WTC Comments on East Suffolk Council ('ESC') Draft Cycling and Walking Strategy Document

Planning Committee Approved

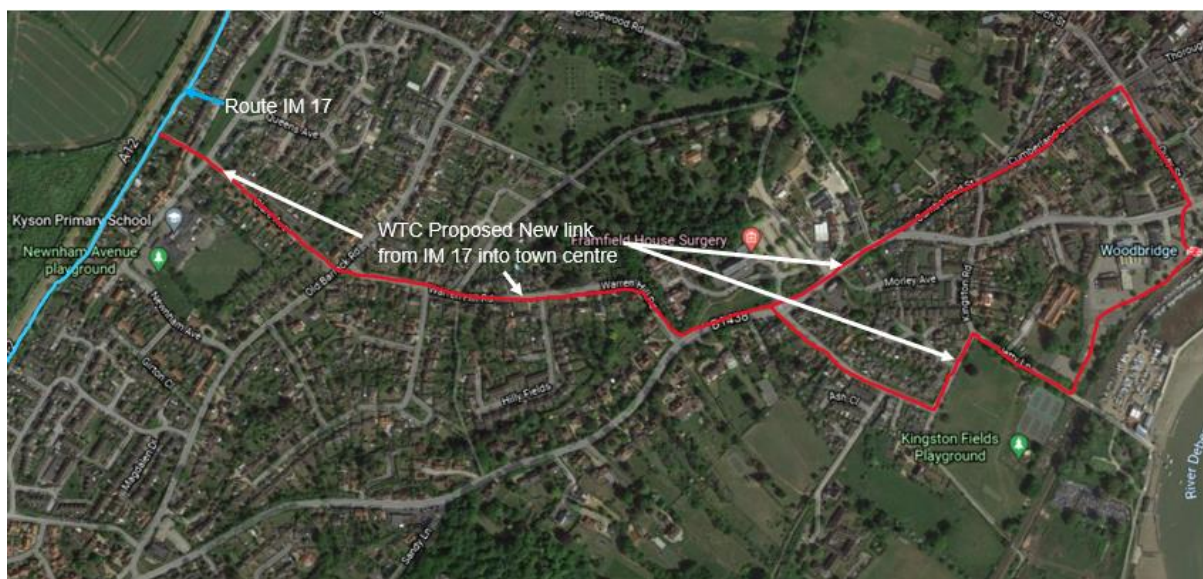
IM 17 between Seckford Hall Road and B1079 roundabout could usefully be diverted for much of its length onto the access track behind Peterhouse Crescent which extends all the way to

Bilney Road rather than being immediately alongside the A12. It would be more attractive and safer being more remote from the A12. There would be minimal impact on the mature trees than the ESC proposed route beside the A12 would have. This current access track is little used and unattractive with some fly tipping. It also has a track linking it to Peterhouse Crescent directly in line Clare Avenue.

Flooding Issues on ESC Proposed IM 18 Route

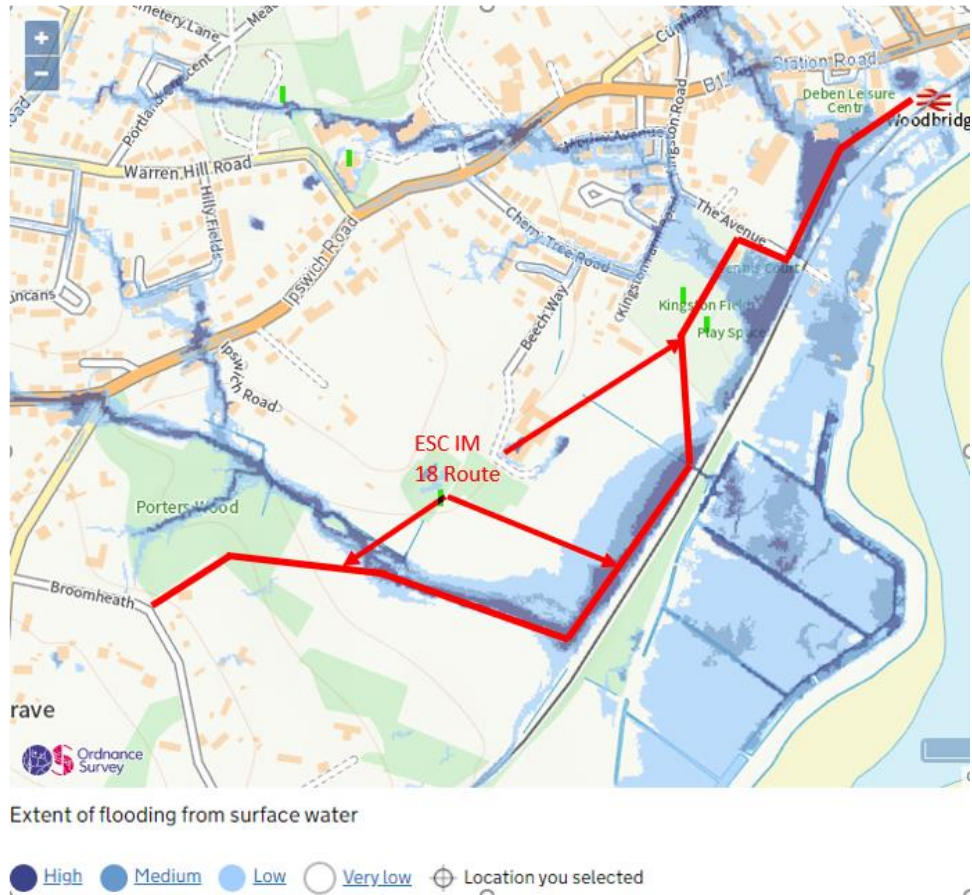
- The route from halfway down the valley slope and along the western edge of the railway is prone to flooding. The government surface flooding map (see attached) show a high risk of flooding. Additional maps at <https://check-long-term-flood-risk.service.gov.uk/map> also show this section of the route has high risk flood water velocities and depths of floodwater between 300 and locally over 900mm, also deemed high risk. WTC consider substantial earthworks and drainage works would be essential to make this a safe route.

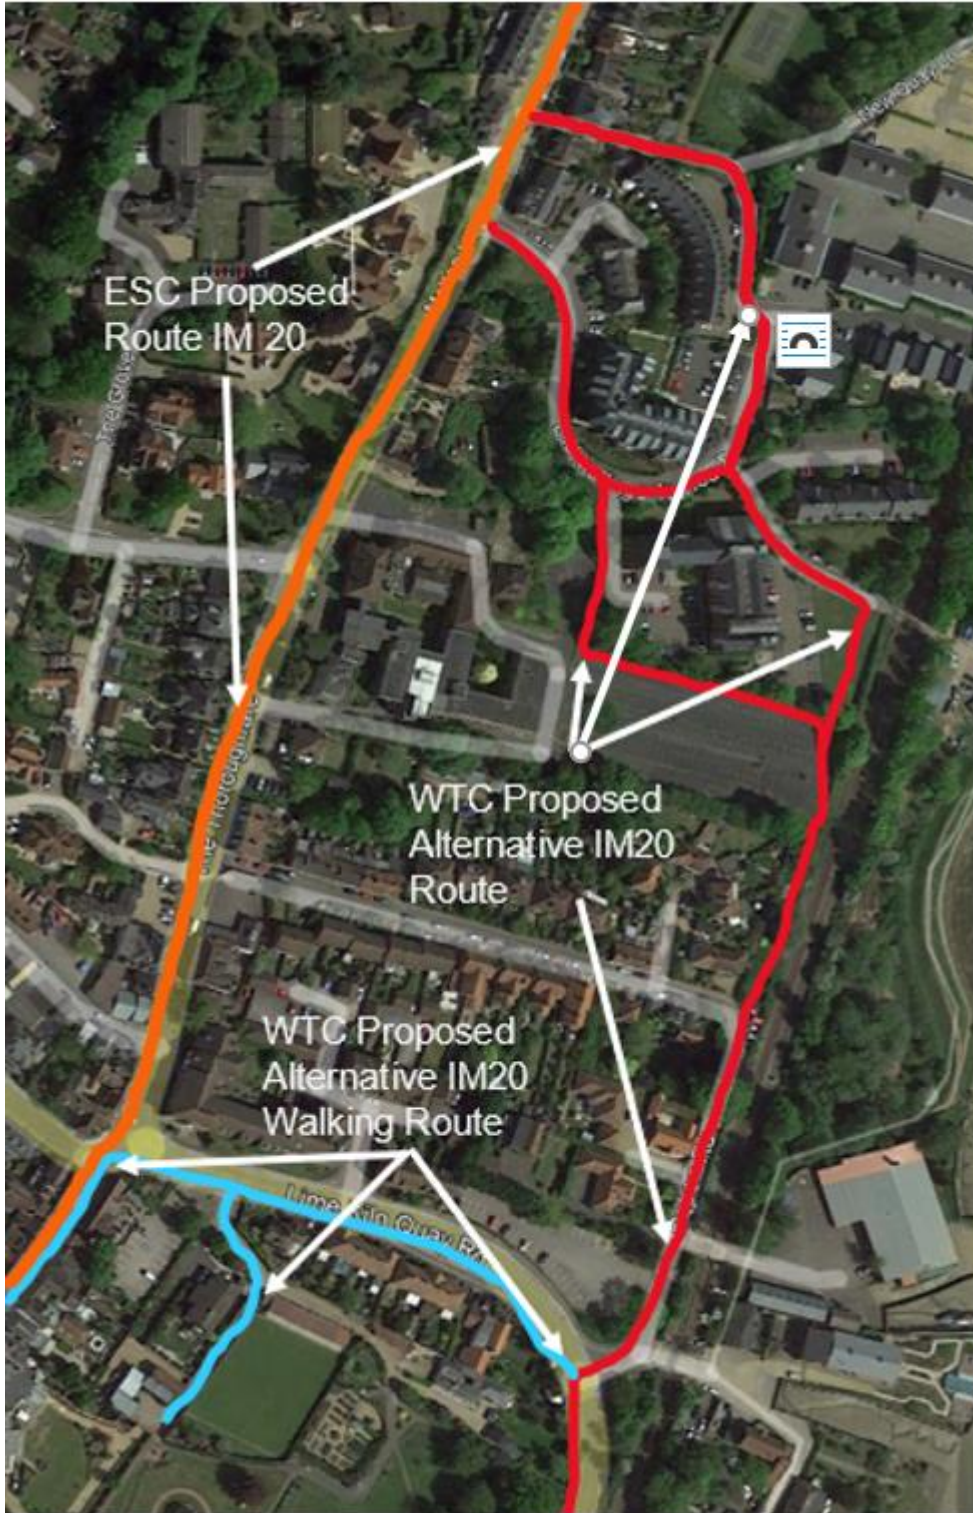
WTC would wish to clarify that the road between the traffic lights and Pytches Road is the northern part of the Thoroughfare and thus the draft strategy recommendation incorrectly refers to the traffic lights being "*north of the Thoroughfare*".

WTC, whilst highly supportive of more cycling, do not wish to see the Thoroughfare between the traffic lights and Cross Corner as a busy cycle route due to the considerable foot fall and cross pedestrian use. WTC see this area as a destination with cycle parking adjacent to it. To that end WTC is about to add cycle racks at Selwyn Gardens, adjacent to the traffic lights. WTC welcomes the Strategy's intention for further cycle storage, but this should be adjacent to, but not along, this part of the Thoroughfare.
